PCN #: 2325 – Rev 3 (Final)

PCN Title: Fab Porting from Global Foundries to MagnaChip

PRODUCT CHANGE NOTICE**PCN-2325 REV 3 - FINAL**

Old Top Marking

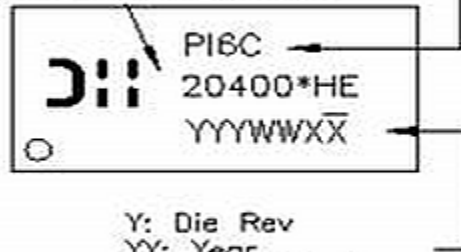
Y: Die Rev
YY: Year
WW: Work Week
1st X: Assembly Code
2nd X: Fab Code
Date Code per MA-1251
